Zoning Board of Appeals Meeting of June 10, 2026

Application No. PUD-2026-01 GDP

Applicant: Ken Salah, Capo Construction

Requested Actions: General Development Plan (GDP) for a residential development and rezoning of a portion of the subject property from RM, Multifamily Residential, to PUD, Planned Unit Development.

**PROPOSED RESIDENTIAL
 PLANNED UNIT DEVELOPMENT**
 OF
**PART OF LOT 6 AS DESIGNATED UPON
 THE PLAT OF MALOTT FARM**
 BEING A SUBDIVISION OF PART OF THE SOUTH
 HALF OF SECTION 4, TOWNSHIP 45 NORTH, RANGE
 2 EAST OF THE THIRD PRINCIPAL MERIDIAN
 VILLAGE OF ROSCOE
 WINNEBAGO COUNTY, ILLINOIS

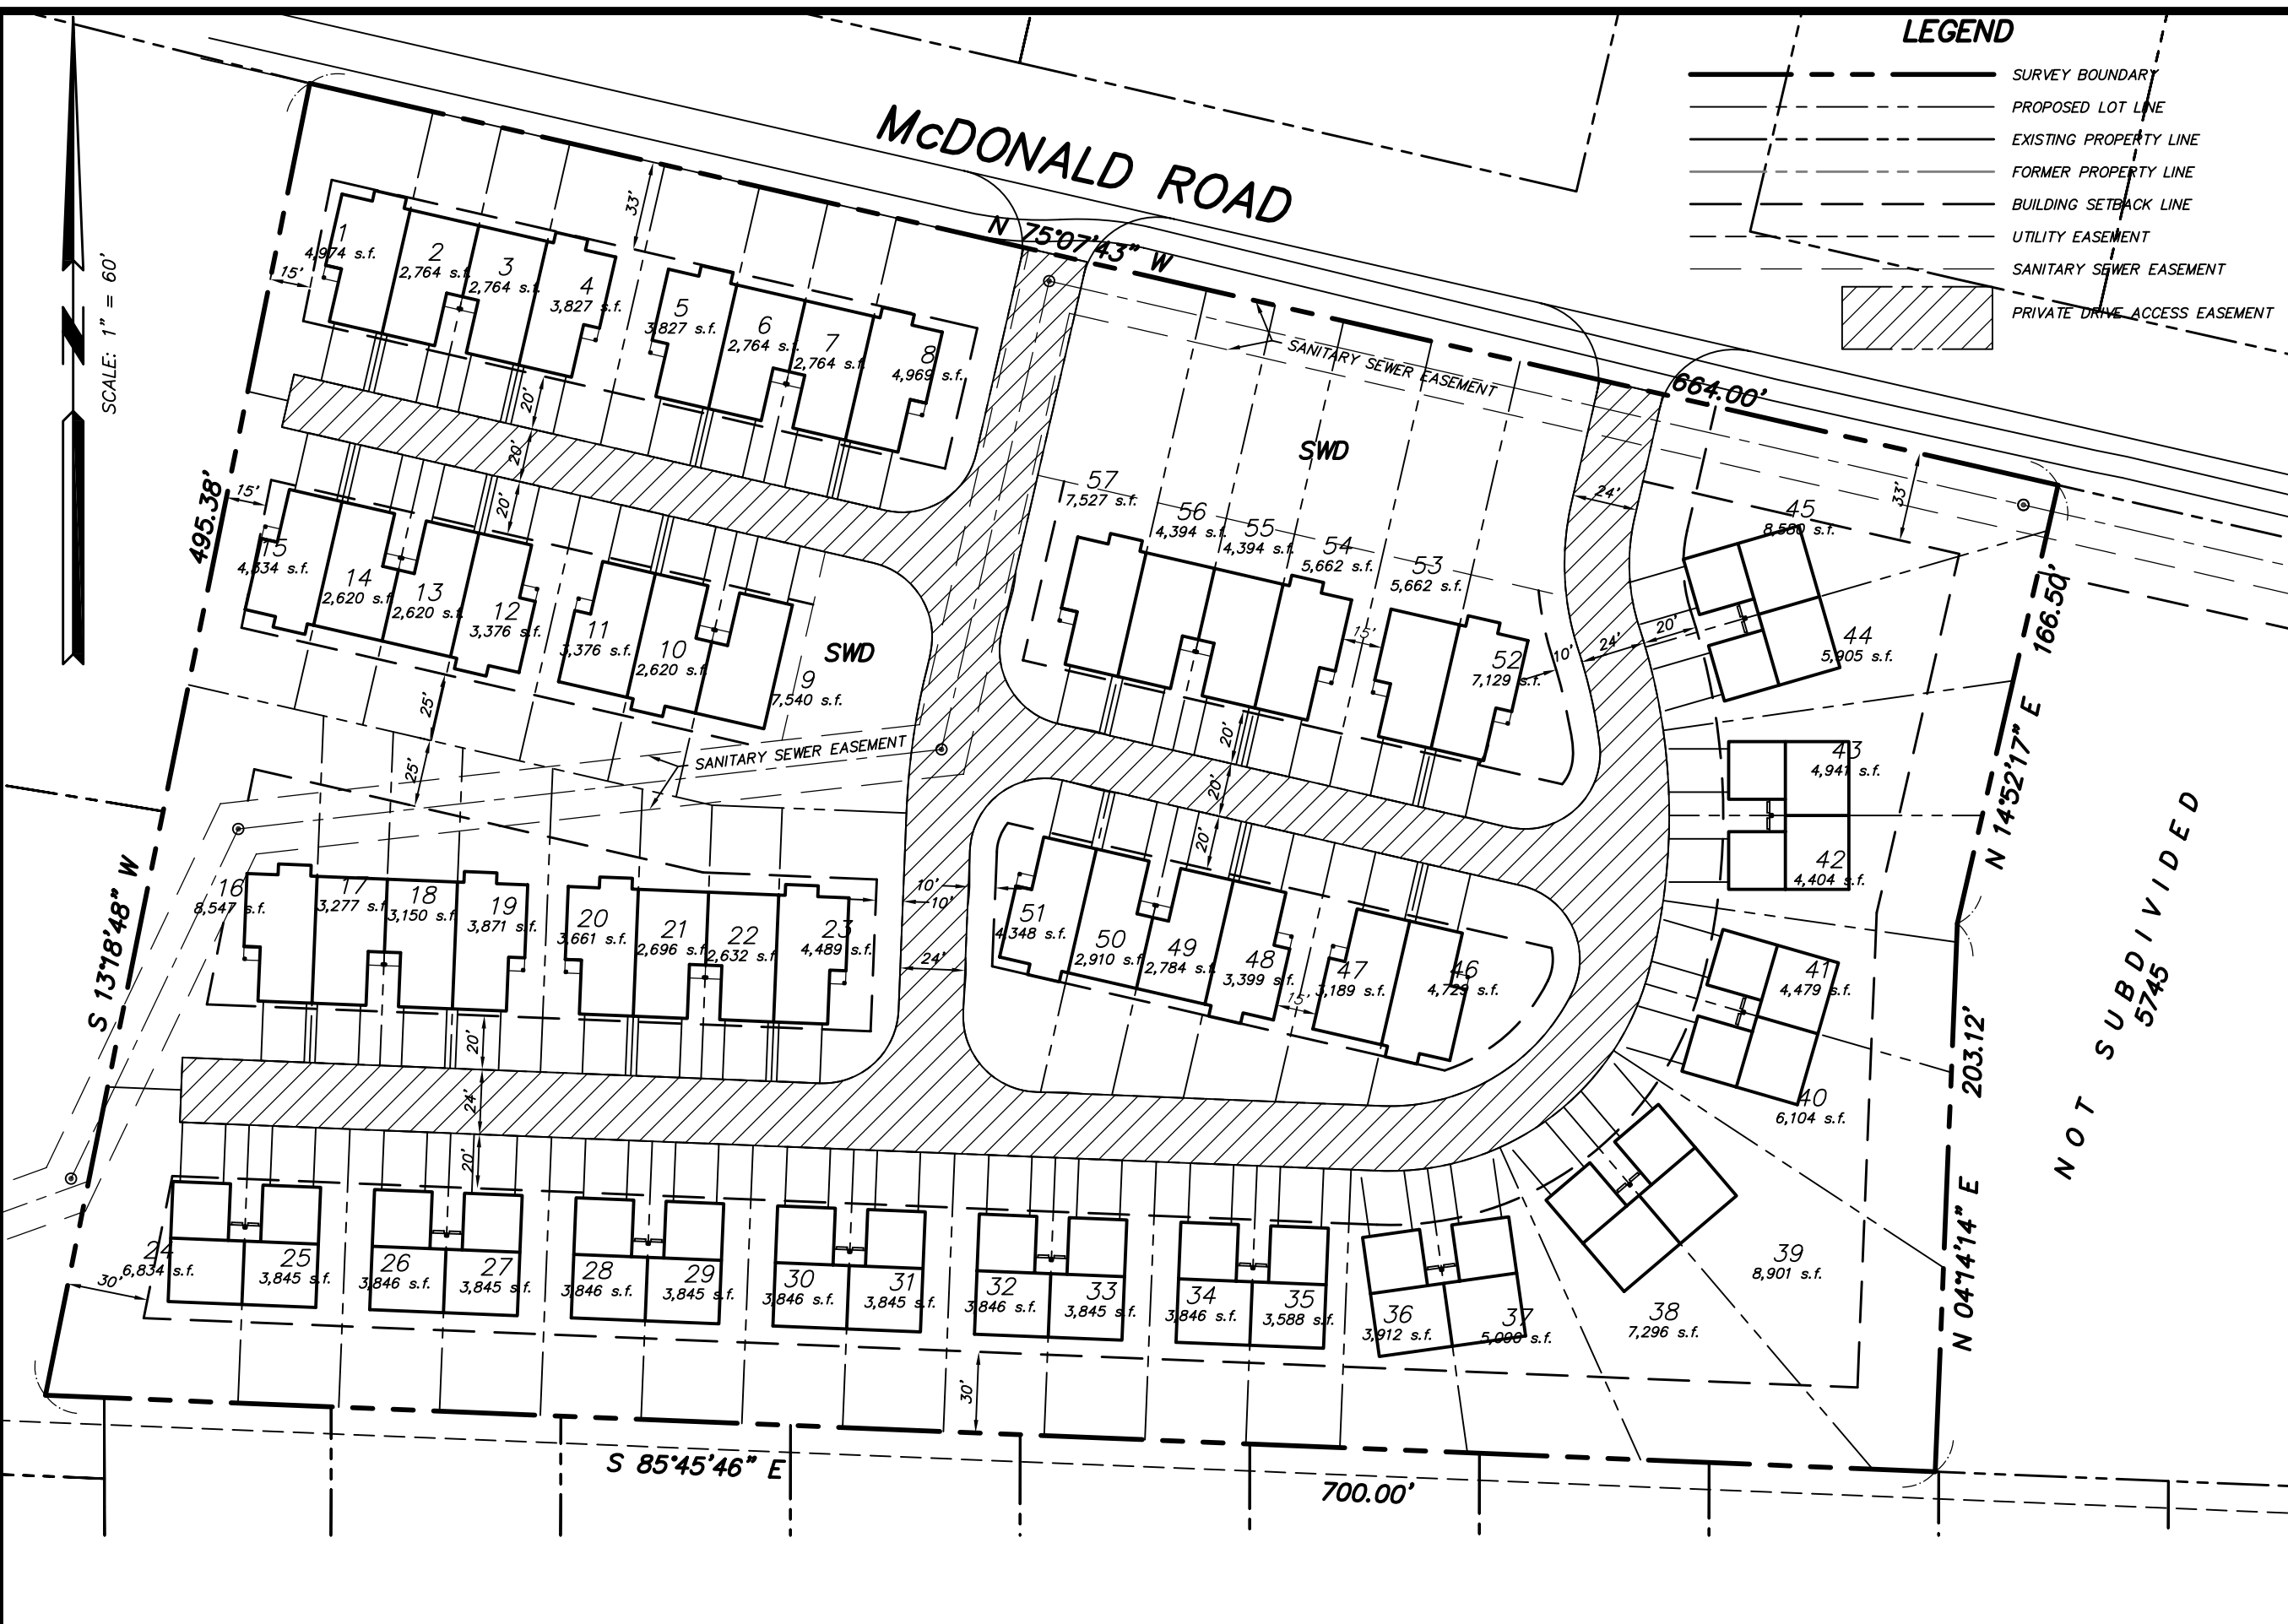
- Water
 - Potable water infrastructure exists on the north and south side of the site. Developer shall be responsible for coordinating with North Park Public Water District on the design and permitting of any required water main extensions and water service connections during the Specific Implementation Plan (SIP) phase.
- Sanitary
 - Sanitary sewer infrastructure exists on the site. Developer shall be responsible for coordinating with Four Rivers Sanitation Authority on the design and permitting of any required sewer main extensions and sewer service connections during the SIP phase.
- Stormwater Management
 - Stormwater detention facilities are indicated on the conceptual site plans. An approved drainage study will be required as part of the SIP phase to demonstrate compliance with applicable stormwater management requirements.

- Private streets are being proposed throughout the development. The Village will require necessary maintenance agreements to be provided during the SIP phase.

- Interior sidewalks and/or pedestrian paths are recommended by staff and the developer shall provide connections to the McDonald Road path. Pedestrian accommodations will be worked through during the SIP phase.
- If it is determined during the SIP phase that street lighting is necessary, the developer shall be responsible for constructing and maintaining street lighting.

- Village Code requires proposed street access points to align with existing entrances located on the opposite side of the roadway and does not allow dead end roads without an appropriate turnaround. As an alternative, Village Staff may consider median treatments that restrict access to right-in/right-out movements to satisfy the intent of this requirement. A Traffic Impact Analysis (TIA) will be required and will determine final access points and required public improvements (turn lanes, restricted access points, etc.). An approved TIA will be required during the SIP phase.
- Due to limited overflow parking, which may lead to residents parking on the private roads, staff recommends no-parking signage to be considered along internal roadways during the SIP phase to prevent conflicts with clear space requirements for emergency access and vehicular circulation.

- Proposed 20-foot-wide access lanes may not meet emergency access requirements and may be subject to change during the SIP review process.
- Internal dead end roadways do not appear to provide adequate maneuvering space or turnaround areas for emergency vehicles, including fire apparatus and ambulances. Staff is recommending incorporation of dead-end turnarounds for emergency access and snow plowing. Final roadway configuration will be worked through during the SIP phase and will be subject to Harlem-Roscoe Fire Department review and approval.

1. The General Development Plan (GDP) is approved contingent upon review and approval of a final subdivision plat.
2. The applicant shall submit a Specific Implementation Plan (SIP) application containing all materials and information required by the Village Zoning Ordinance.

3. Any modifications, recommendations, or requirements identified by the Village Engineer shall be incorporated into the SIP and subsequent development approvals.

7. The Applicant is required to perform a Traffic Impact Analysis (TIA), provide a copy to Village Staff, and incorporate any recommendations from the report into the SIP.

8. The applicant shall coordinate with the Village Engineer and Fire Department to confirm the final street design, roadway geometry, and emergency access requirements.

9. The SIP shall include pedestrian circulation and connectivity on site and to the existing McDonald Road path.
10. Fences and accessory structures shall comply with the Village Zoning Ordinance. Any future fence or accessory structure shall be subject to applicable Village permitting requirements.
